King's Daughters

KD-3123.0-26

GC Services for UK King's Daughters Medical Center – Greenup Co. Urgent Care/Family Care Medical Office Building

ADDENDUM # 02

1 POWER PLAN
1/8" = 1'-0"

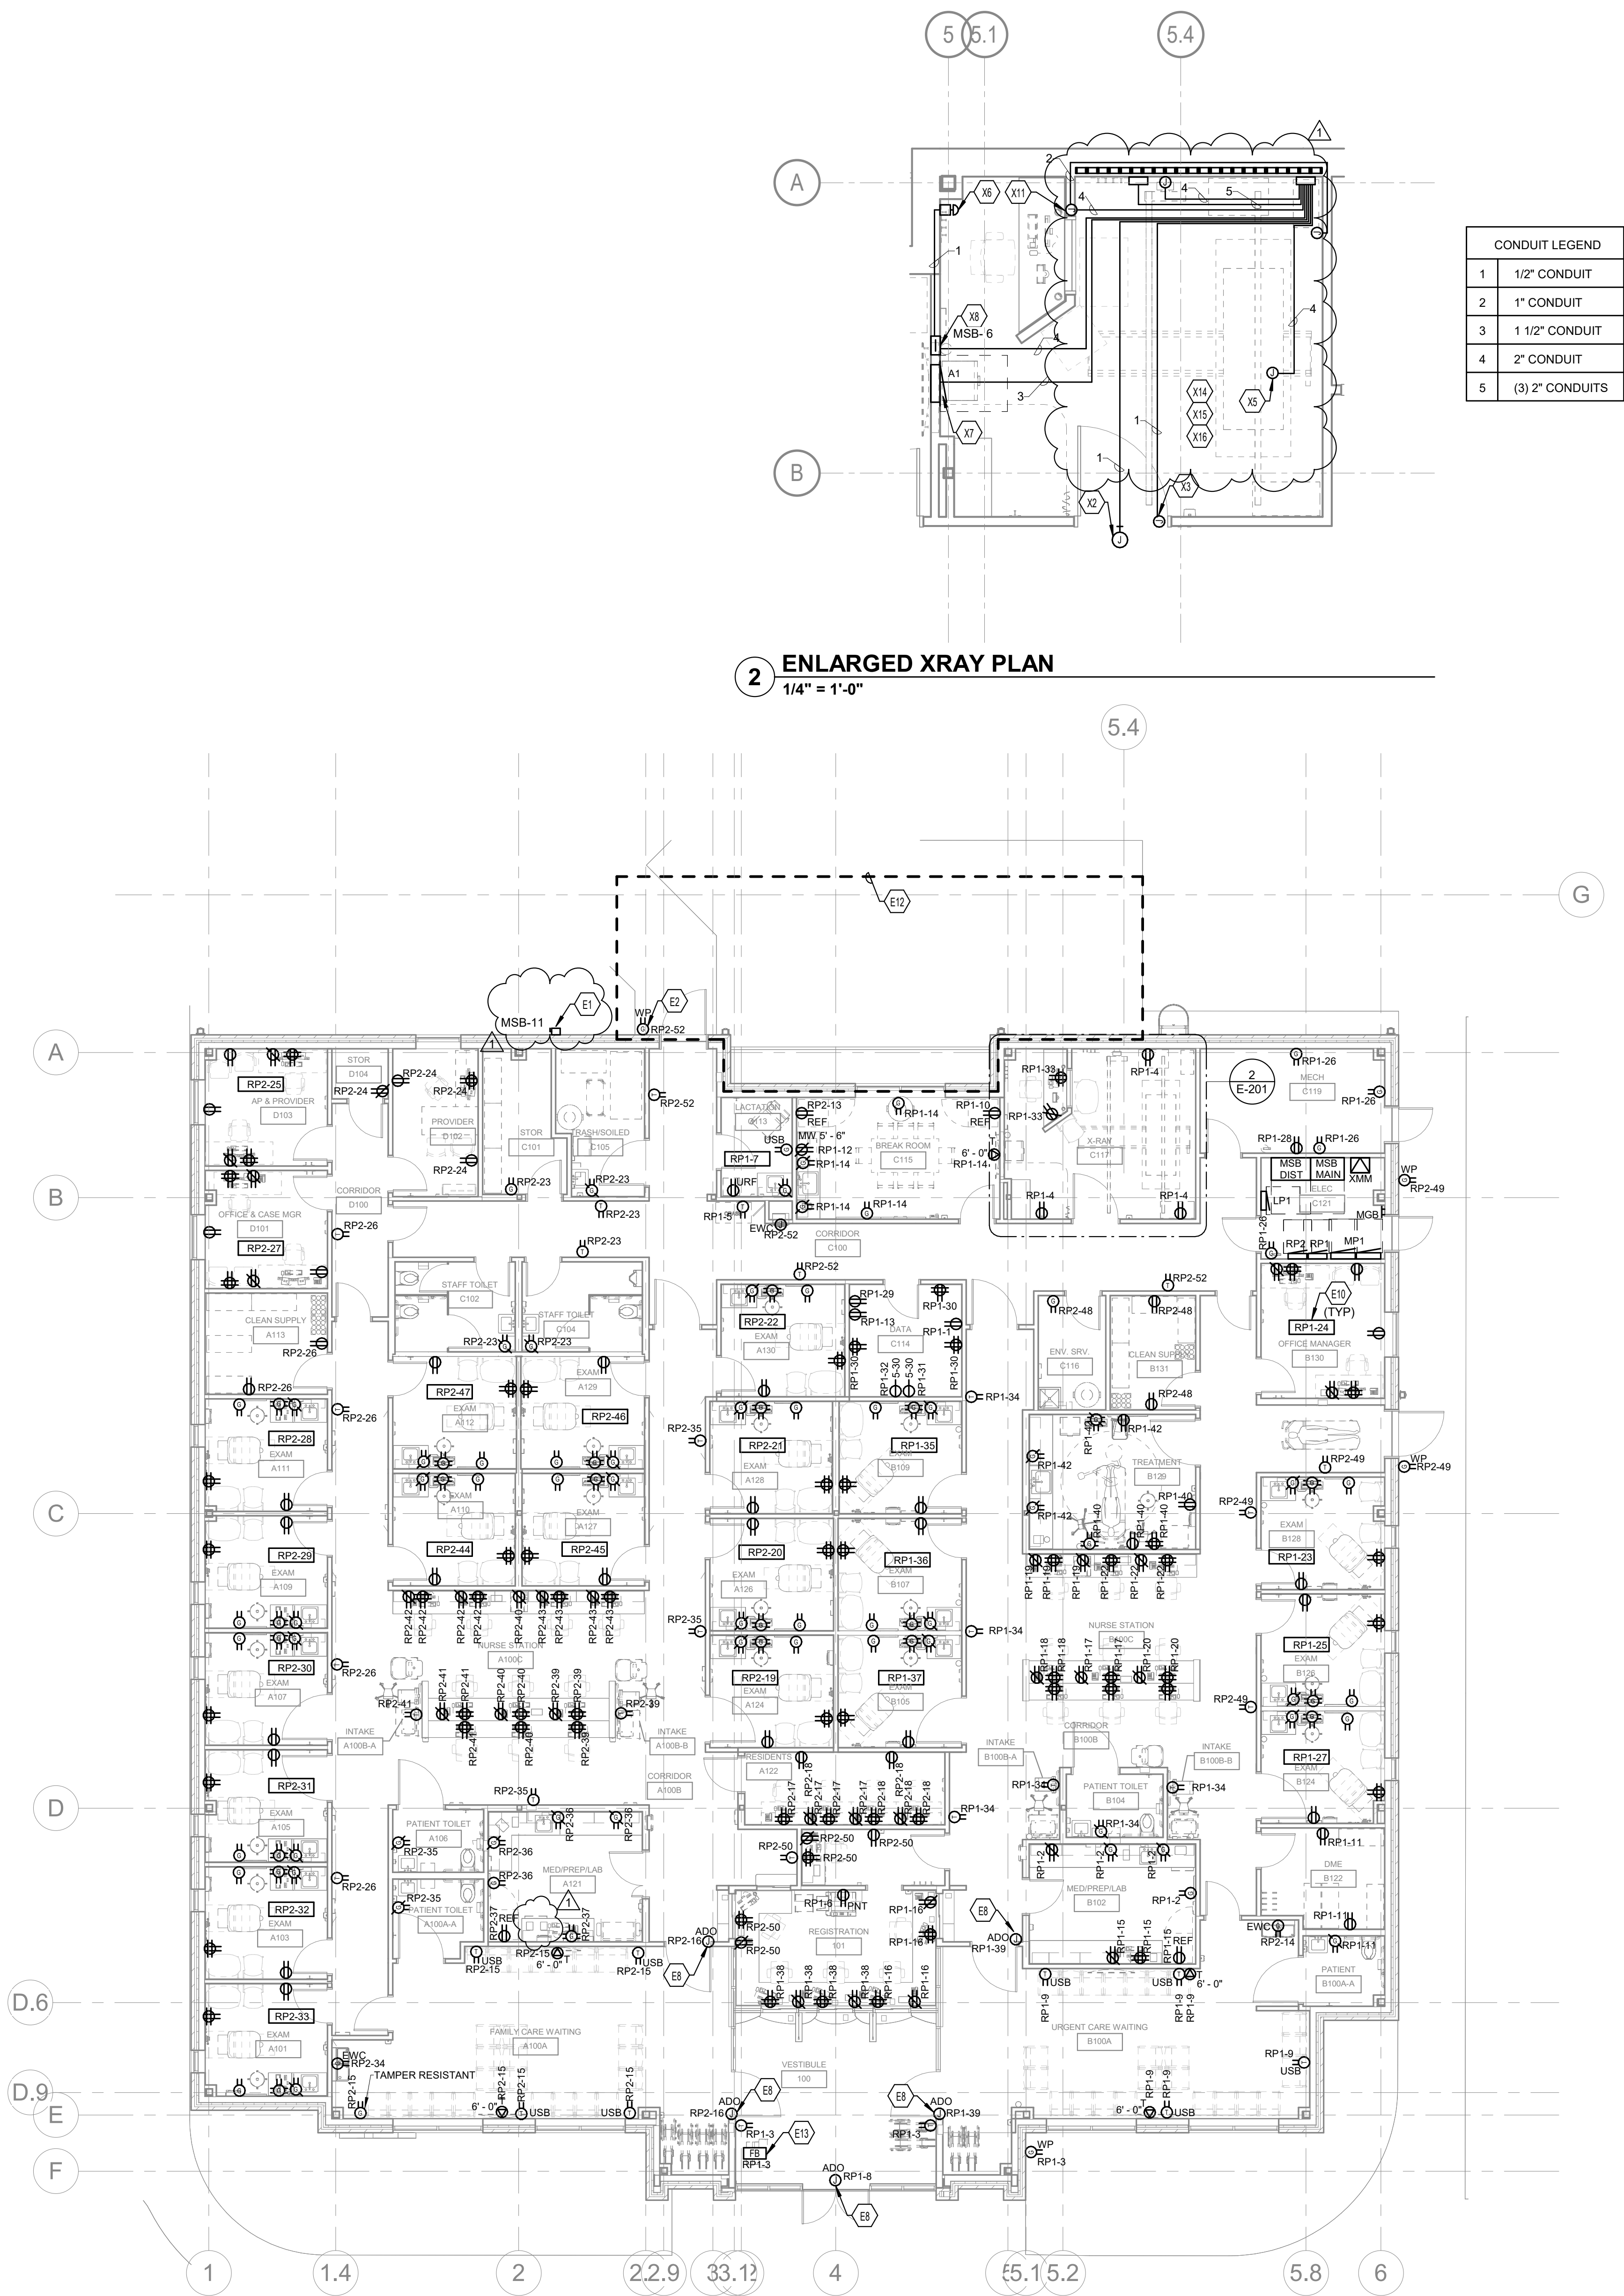
Refer to the attached revised Sheet E-201 Power Plan

- Removed receptacle and circuit for pediatric under counter fridge. Fridge was removed from scope.
- Note E1 updated to provide additional clarification for mobile mammography power connection.
- Updated X-Ray room conduit and device layout to match update from vendor.

E-201

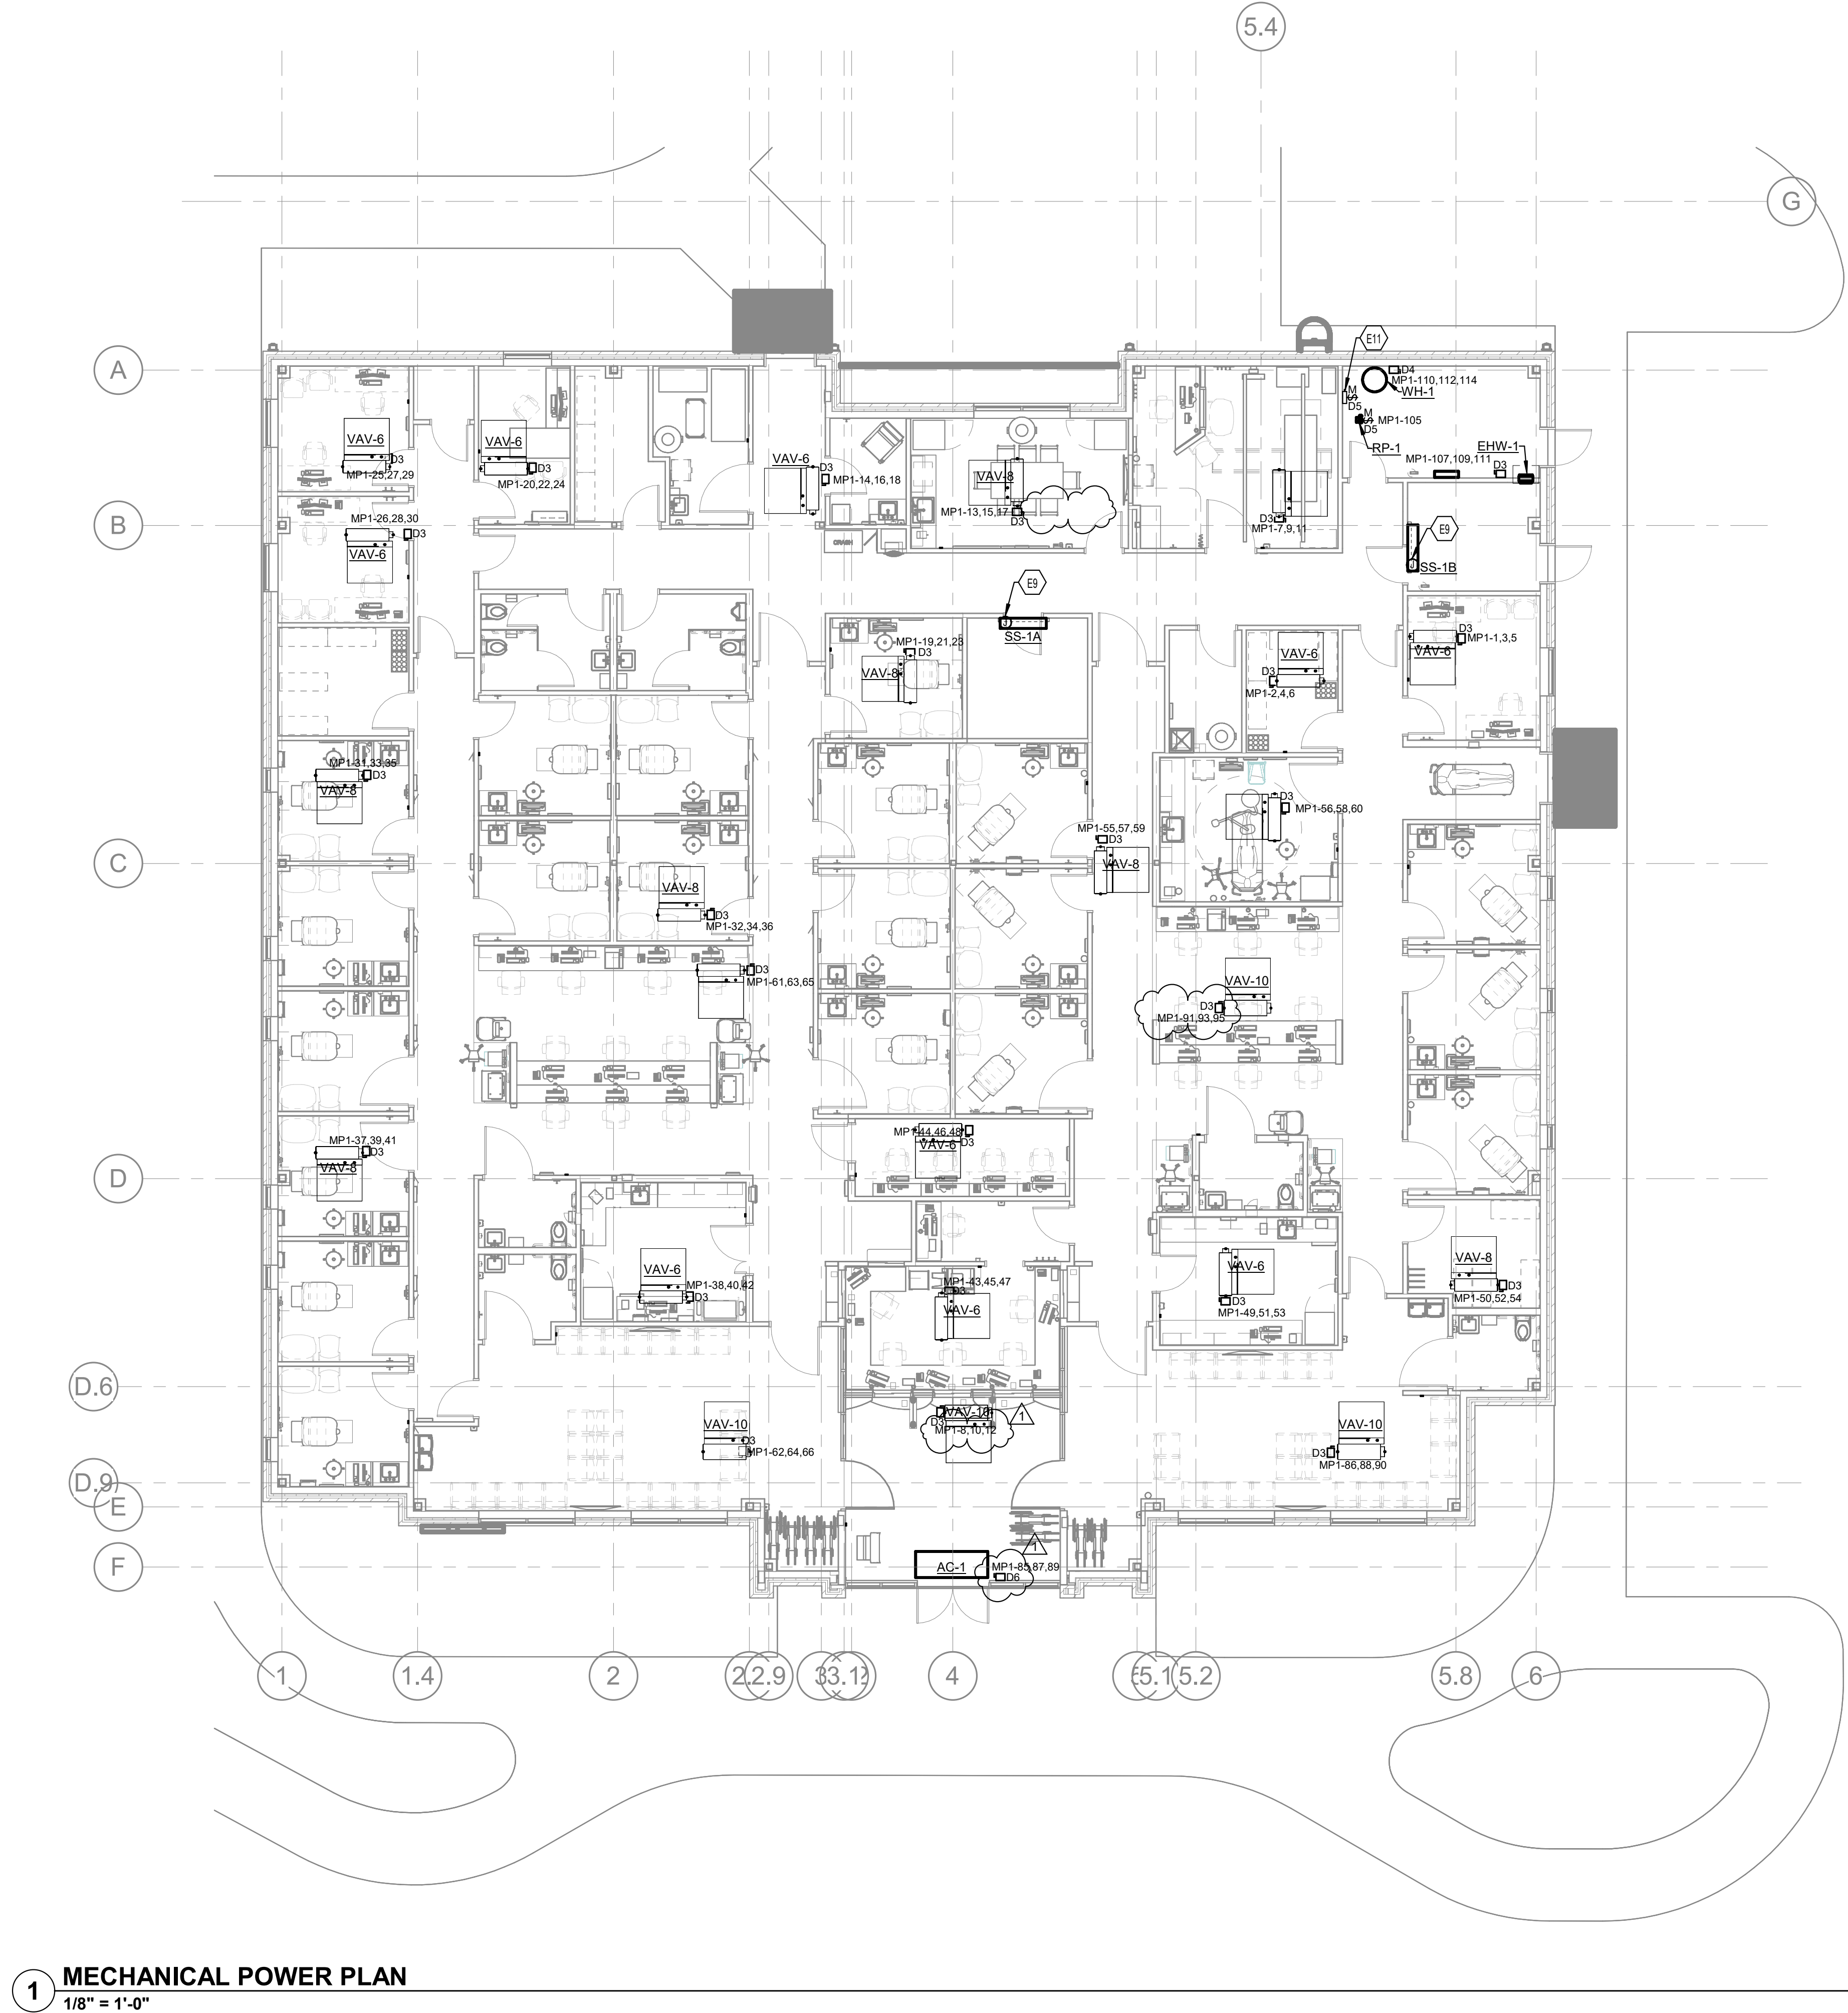
Refer to the attached revised Sheet E-301 Mechanical Power Plan

- New type D6 to clarify contractor supplying disconnect for air curtain.
- Moved VAV for CT alternate to sheet E-601 to clarify scope.

- Switched circuits so CT alternate VAV is on SEC. 2 of panel MP1.
- Added missing circuit tag for circuit MP1 -91, 93, 95.
